U.S. Army Corps of Engineers Information Needs – June 2009

Preparation for Bellefonte Units 3 and 4 Corps of Engineers Site Visit, July 8-10, 2009

COE INFORMATION NEED: COE-4

COE INFORMATION NEED: COE-5

FIGURE 5.6-1
Transmission Sensitive Habitat

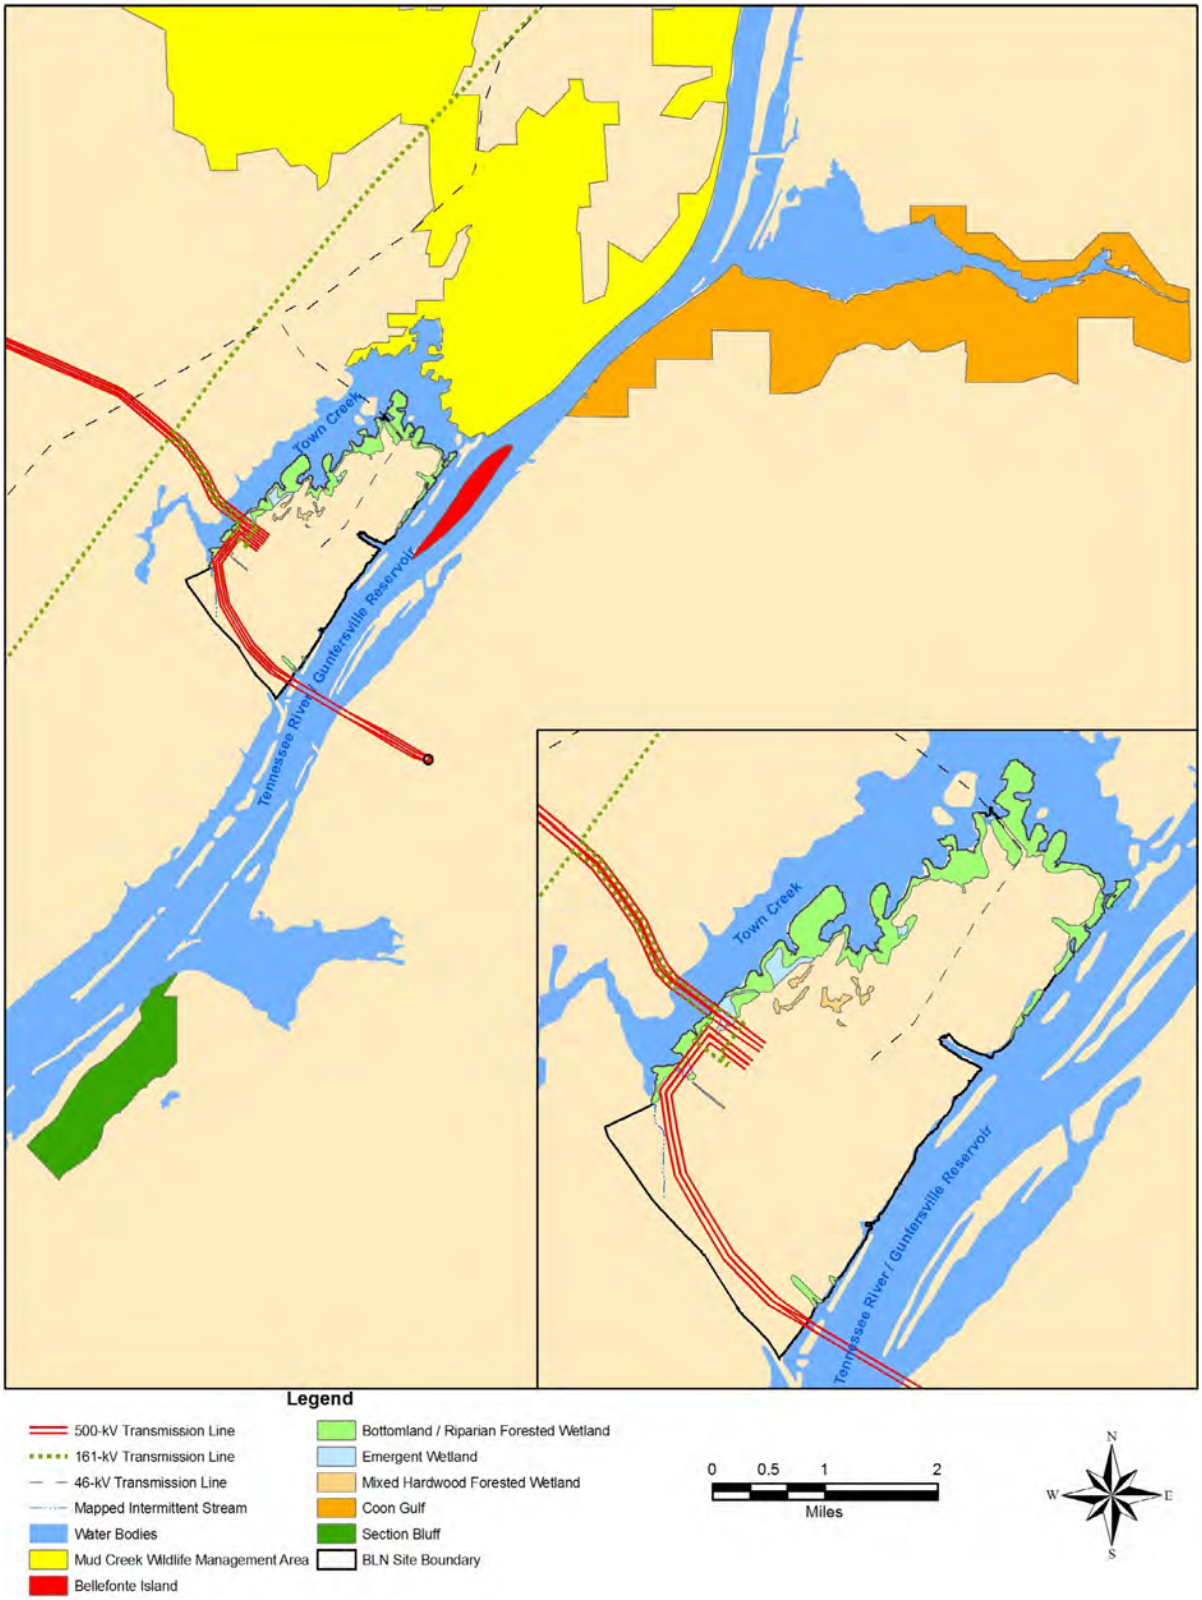
Provide an SME and supporting data and information/references to discuss the techniques to be used by TVA to avoid and minimize impacts to waters of the U.S. at the Bellefonte Site due to the pre- construction, construction and operation of Bellefonte Units 3 and 4. The description should include but not be limited to:

Effects of transmission corridor maintenance on terrestrial and aquatic ecosystems during operations are addressed in Section 5.6, along with TVA maintenance procedures and measures

to limit impacts. Figure 5.6-1 illustrates habitat that is sensitive to transmission lines/corridor maintenance, and the figure is provided as an attachment.
